AUXILIARY SENDER FRAME
EQUIPMENT DESIGN REQUIREMENTS
NO. 1 CROSSBAR AND PANEL SYSTEMS

1.001 This addendum supplements Sections 815-200-151, 816-500-150, Issue 6.

1.002 This addendum is issued:

Fig. 6—Cabling Diagram and Location of Units for Outpulsing Directory Number Feature

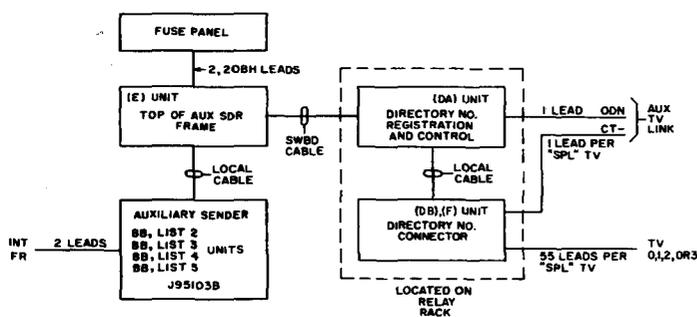
(b) To change Fig. 5 and 6 to reflect TV0, 1, 2, and 3; and add Fig. 10.

(a) Figures 5 and 6—Revised.
